Item ID: D212-664-201TRN

Item Name: Crosstube Turning Detail

DART AEROSPACE LTD	Work Order: 99771
Description: Crosstube Assembly (205/212 High Aft)	Part Number: D212-664-241
Inspection Dwg: D212-664-241 Rev: D	Page 1 of 2

DRAWING NO. D212-664-241	TITLE CROSSTUBE ASSY (205/212 HI AFT)	REV. D	DART AEROSPACE LTD ENGINEERING ORDER		D.E.O. NO. D212-664-241-D-1	SHEET NO. SHEET 1 OF 2	SCALE NTS
DRAWN	CHECKED	MFG. APPR.	APPROVED	DE APPR.			
DATE 11.04.07	DATE 11.04.11	DATE 11.04.12	DATE 11/04/12	DATE 11.04.12

D212-664-241/-241B
ASSEMBLY DETAIL

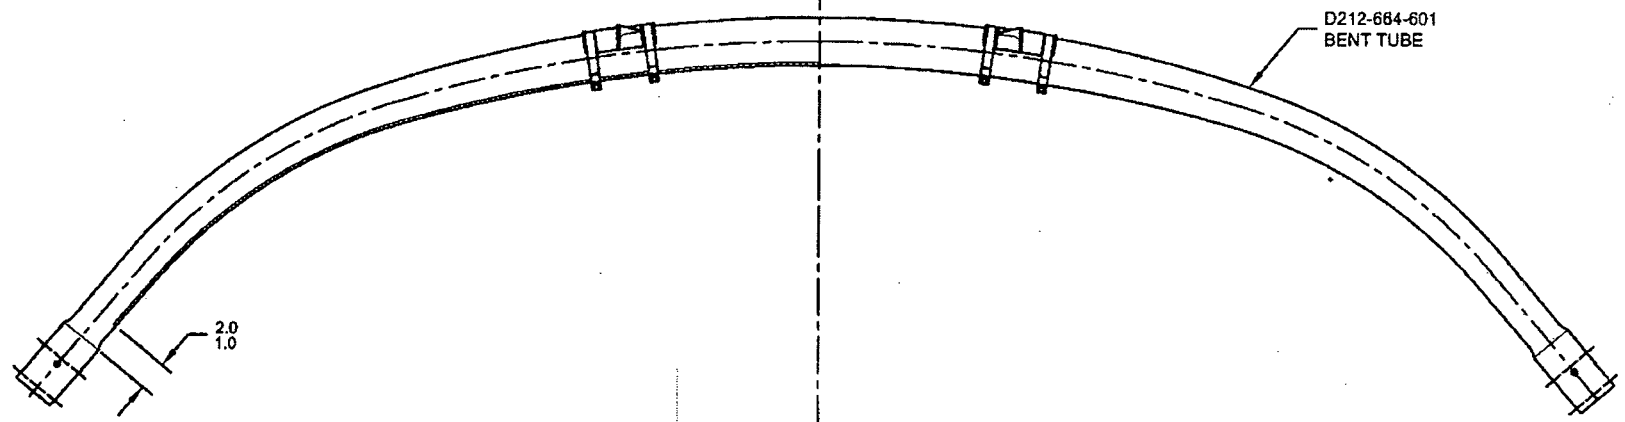
PURPOSE:

ADD AN INSPECTION WINDOW TO UNDERSIDE OF CROSSTUBE.

MASK AREA PRIOR TO PAINTING,
REMOVE MASKING AFTER PAINT
AND APPLY CLEAR COAT

NOTES 2 OF SHEET 1 IS AMENDED AS FOLLOWS:

- 2) FINISH: CHEMICAL CONVERSION COAT PER DART QSI 005 4.1
PRIME INSIDE AND OUTSIDE PER DART QSI 005 4.2
MASK UNDERSIDE OF CROSSTUBE AS SHOWN (HATCHED AREA) AND
PAINT OUTSIDE PER DART QSI 005 4.2
REMOVE MASKING AND APPLY CLEAR COAT
